This document is a proposal to informal document GRE-85-20 from GTB; the changes proposed here below in respect to the abovesaid informal document, and the related additional justification are highlighted in blue.

A. New Supplement to the 06, 07 and 08 series of amendments to UN Regulation No. 48

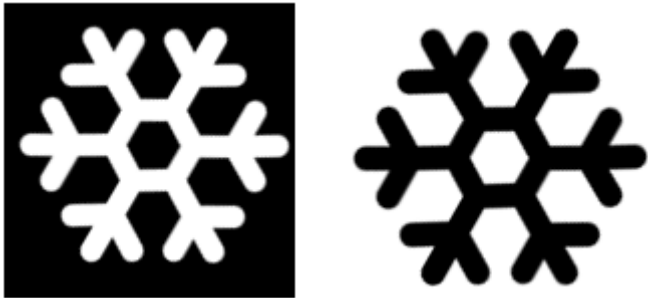
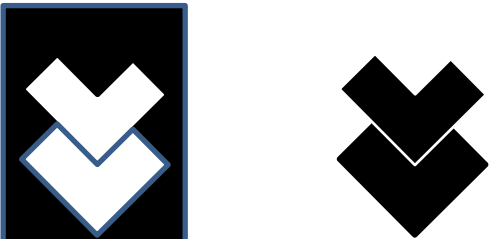
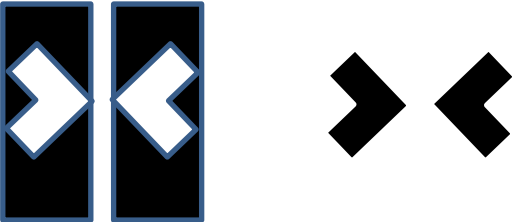
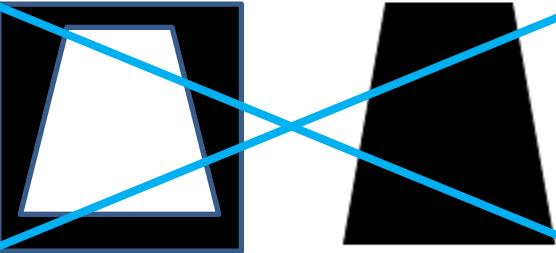
4.1. The wording “and/or transforming” in 6.22.9.3.2.3. has been returned and some editorial corrections have been made, for example, changing “and/or.... is not permitted” to “No nor is permitted” for the purpose of clarification. As described in 4.8 under Justification of the GTB’s proposal, this provision was to introduce a general provision to forbid the flashing and the transformation of symbols. However, the “transforming” has been deleted from 6.22.9.3.2.3. In order to make it consistent, the “transforming” was added.

4.2. If there is no provision to forbid in principle the transformation in this general provision, it can be interpreted that the transformation is not subject to regulation under a certain condition, for example, lamps under park conditions. This provision to forbid the transformation in principle is important because there is a possibility that some manufacturers may put into market driver assistance projection with a transforming function.

4.3. The “Predicted trajectory” should be deleted because it should be considered together with the transformation as a set. Moreover, with respect to the transformation that is strongly requested by the GTB in the next phase, the prohibition of transformation in paragraph 6.22.9.3.2.3. is an important foundation and a prerequisite, considering that the transformation would be proven to have no impact on road traffic and thus be permitted.

6.22.9.3.2.3. No Flashing flashing and/or transforming nor transforming of driver assistance projections is not permitted, unless expressly allowed for the situations described in Annex [16].

No flashing nor transforming of driver assistance projections is permitted
